# Architectural Review Board

Wednesday, April 23, 2025

## N. High Street Renovations Case 25-015MPR

### Case Summary

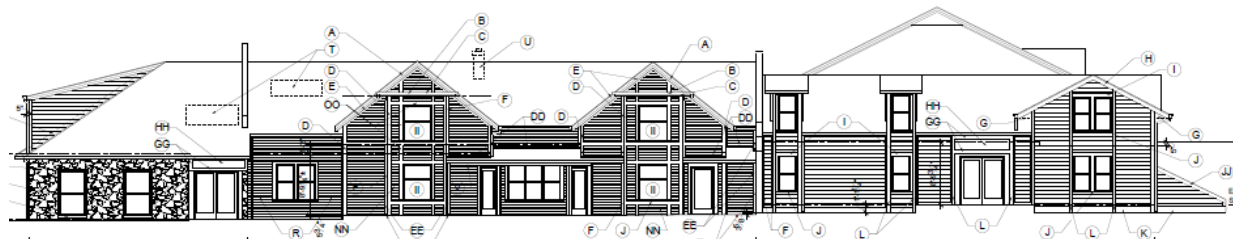
The buildings' massing and scale will not change with this proposal. Improvements are discussed below.

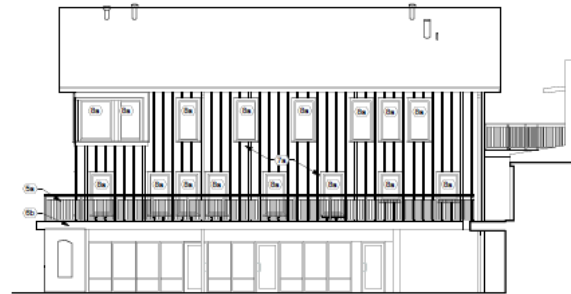
This elevation is hidden behind 72 N. High Street. Major changes are proposed, but will not be visible. They include: removal of a walkway roof and support, removal of four windows,

addition of a stairway access, replacement of one window, and replacement of siding (see Materials). Staff has no concerns with the removals or additions.

*East Façade*

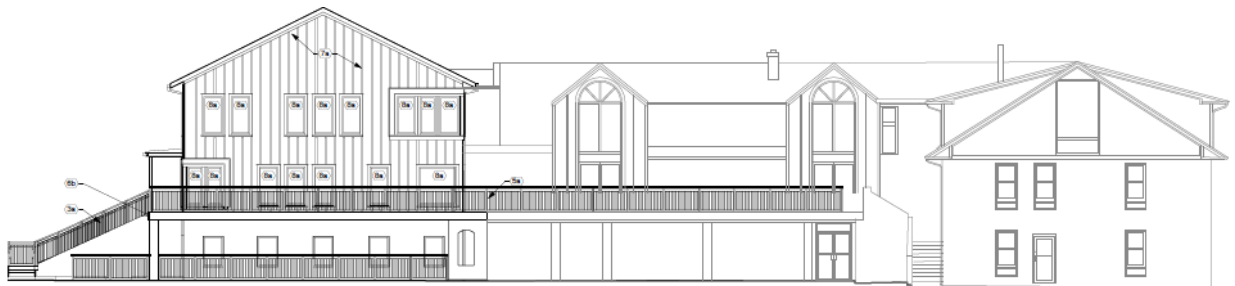
The east façade faces N. Riverview Street, the Scioto River, and the Link Bridge. As with the north façade, the deck cover will be removed and windows replaced with more vertical openings. Portions of grouped corner window details are shown on opposite sides. A new deck and railing system to match that on 72/84 is shown on the ground and second floor levels.

*South Façade*

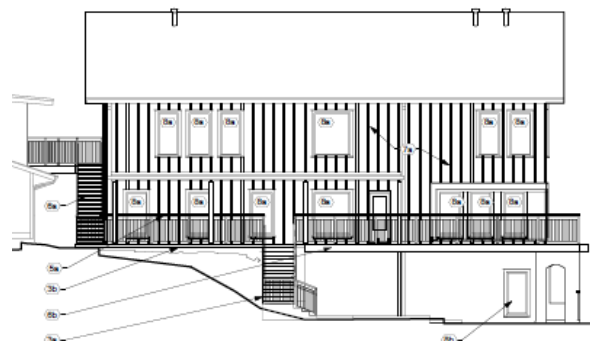
This façade faces North Street. The cross gable on the roof is removed as shown at Informal. Here, the deck has a partial, flat-roofed cover, in response to Informal discussions. The decking and railing remains a major feature of this elevation and helps ground the building to the street. The arched stone Signature Feature is kept, and a new window is immediately to its left.
